**PROPOSED CONSTRUCTION OF
SOUTH LENA POINT SUBDIVISION
WASTEWATER OUTFALL SYSTEM**

Bayview Subdivision – Summary of Wastewater Permits
(Compiled by Lena Extended Neighborhood Association, LENA)

Summary of Questions and Concerns Raised at Public Meeting Proposed South Lena Subdivision

PLAN VIEW
WASTEWATER OUTFALL

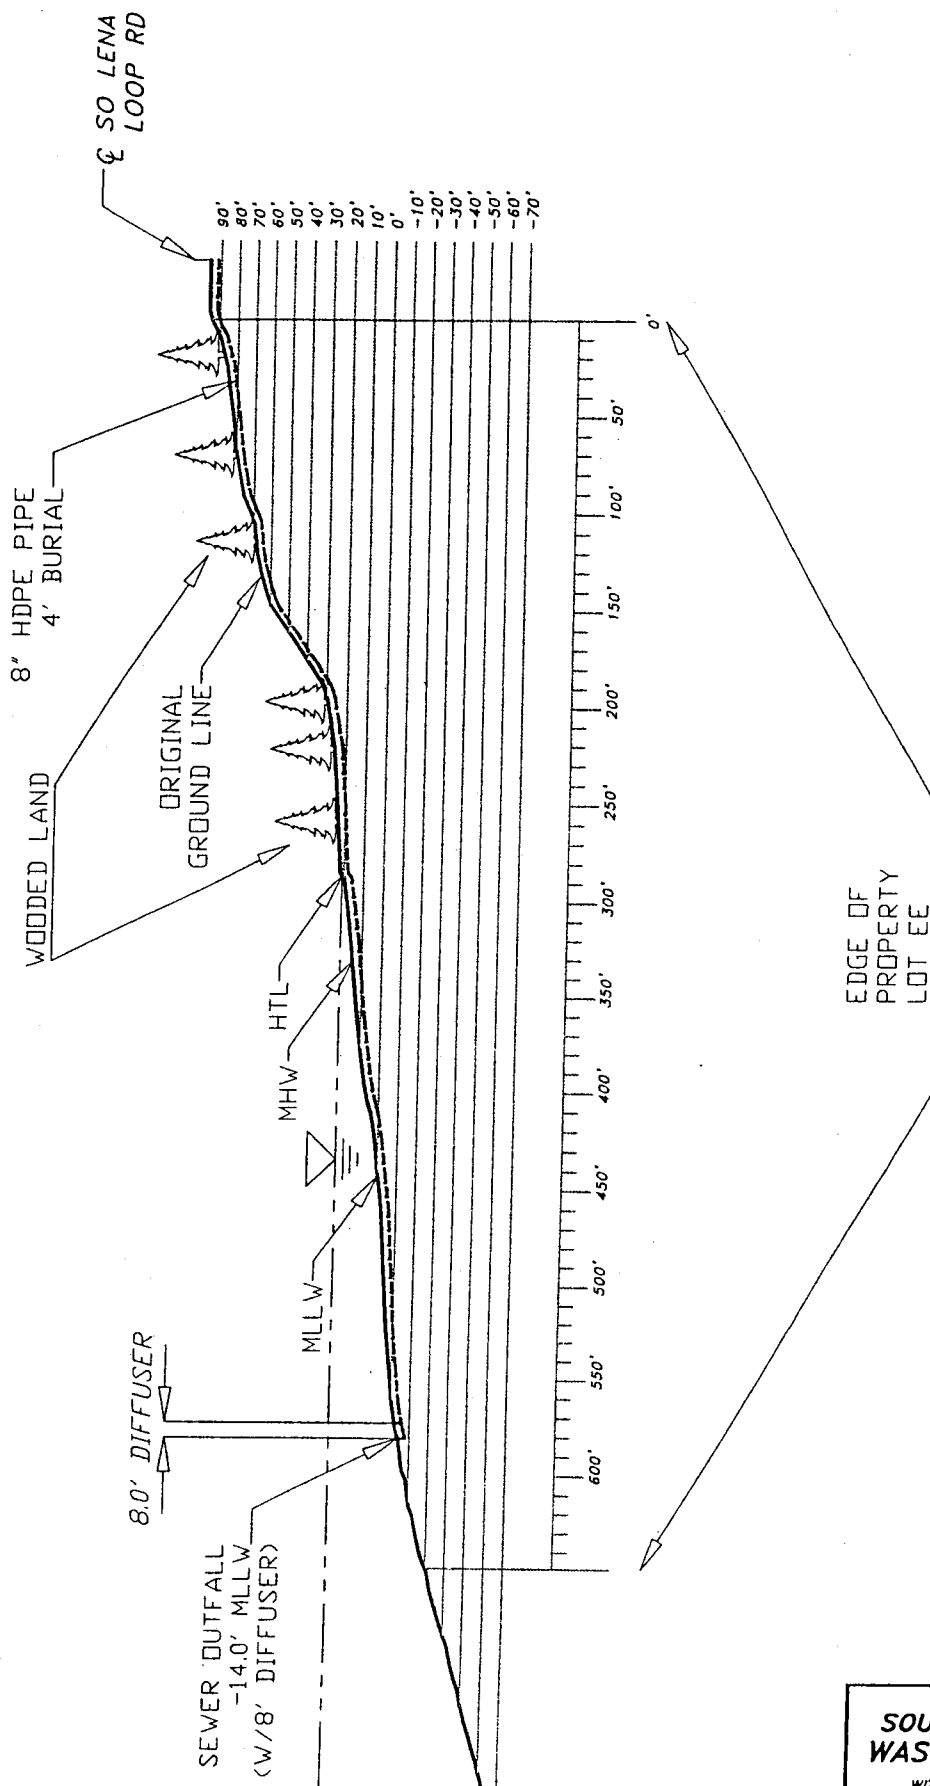
- According an adjacent landowner, Lot EE has blue clay and unstable soils. Currently, large trees (and their roots) seem to be helping stabilize the slopes. *How will the City place the sewer outfall line across Lot EE without destabilizing the slopes?*

- *What will Lot EE look like after the sewer is in place?*

Response: A soils investigation will be done to determine the best method for placement of the line.

Response: The public will likely not notice a substantial change. At this time, the design calls for the outfall pipe to be buried. The City has no plans to develop a beach access trail at this site because there are several other public beach access routes at Lena Point that are substantially superior in terrain, beach, and amenities.
